RE: Legacy Home Health – 3610 Bosque Plaza Lane NW
Grading and Drainage Plan
Stamp Date: 11/02/17
Hydrology File: E12D006F

Based upon the information provided in your submittal received 11/09/2017, the Grading and Drainage Plan **is not** approved for Site Plan for Building Permit. The following comments need to be addressed for approval of the above referenced project:

C-101

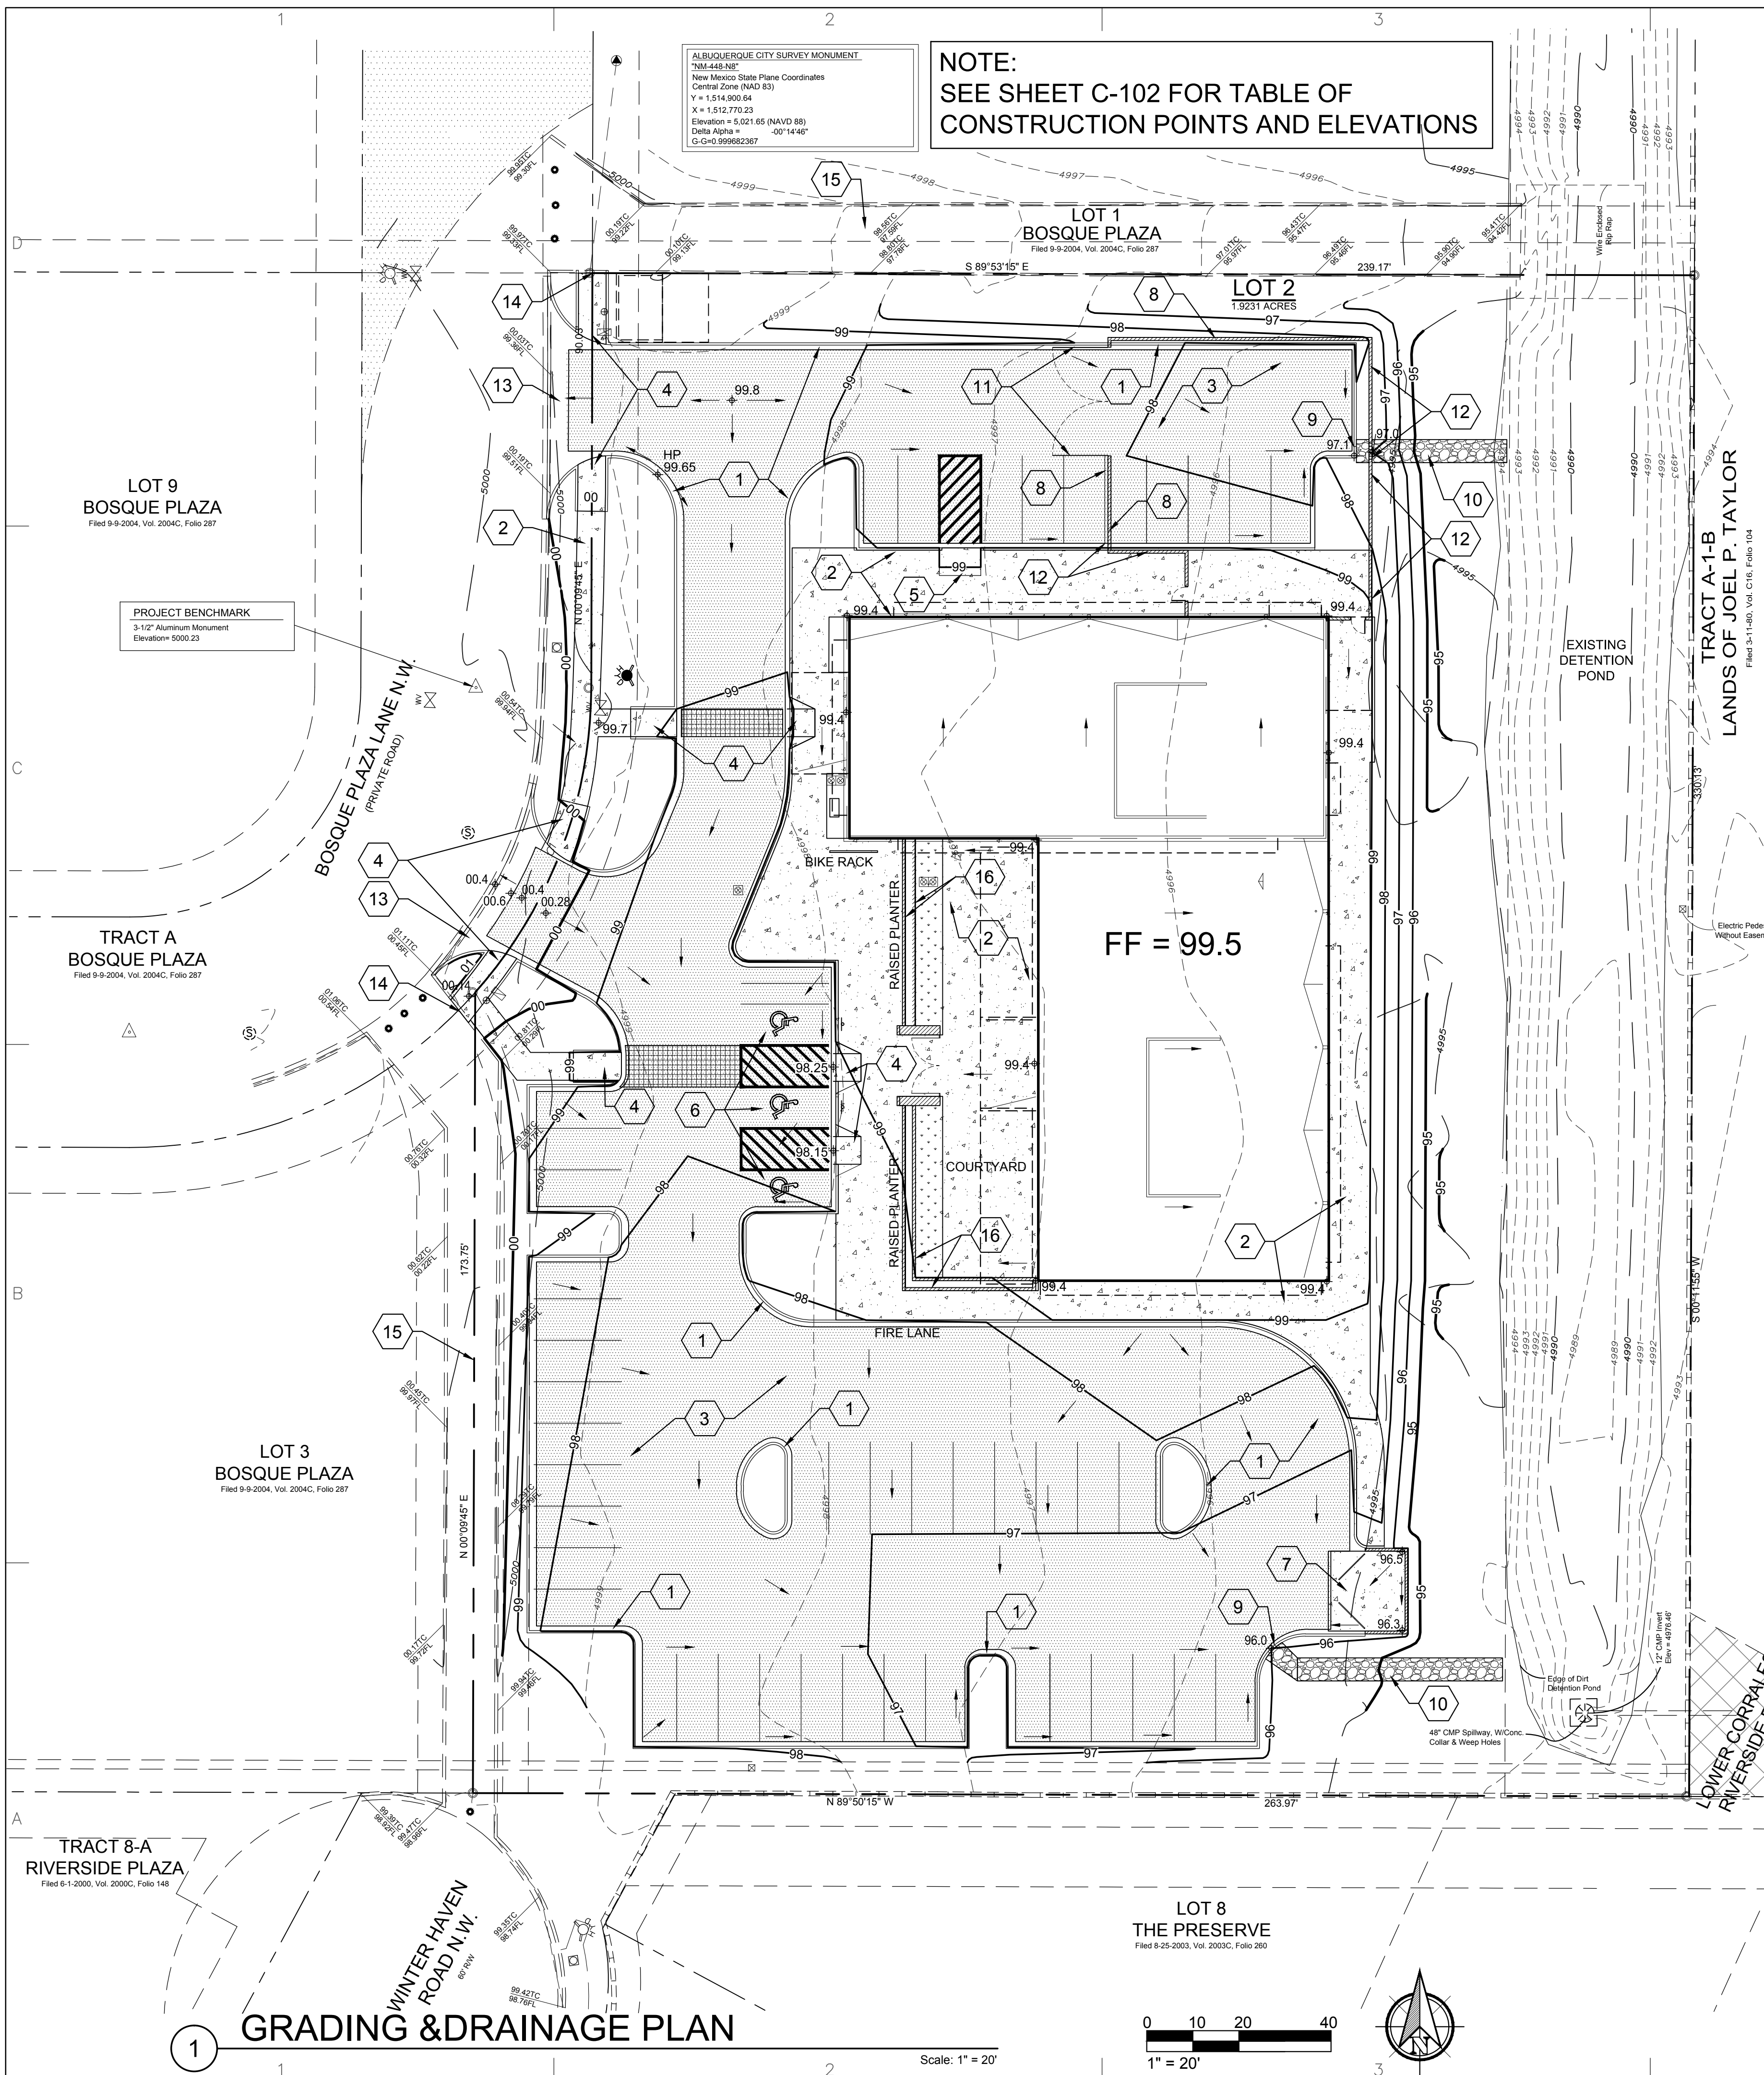
1. Since this submittal is for DRB action, please add the word “Conceptual” to the sheets title and add a note stating “Not for Construction”.

2. Please provide the flood plain effective date to the FIRM information.

3. Please label the existing 40 feet Drainage Easement on the site.

4. Please add the note, “Lot 1 is subject to all restrictions, conditions, and requirements as set forth in that certain “Bosque Plaza Declaration of Easements, Covenants, and Restrictions”, filed in the office of the County Clerk of Bernalillo County, New Mexico on the 28th day of July, 2004 in Book A81, Page 5448.

1. The site currently shows more than 1 acre of disturbance is being proposed. An Erosion and Sediment Control Plan is required and has to be submitted to the storm water quality engineer (Curtis Cherne, PE, ccherne@cabq.gov). Hydrology’s approval for Grading or Building Permit will not be given until the submittal of the ESC Plan.

2. Please include the designed grade points with your submittal.

3. Please provide the weir calculations for the curb cut.
4. Please provide a cross section detail of the proposed riprap.
5. To prove the capacity of the first flush volume in the existing detention pond, please provide a cross-section showing the 100 year water surface elevation as designed in the Master Drainage Report for Bosque Plaza prepared by Tierra West with engineer's stamp date of 9/25/2002. Then show that there is additional capacity for the first flush volume.
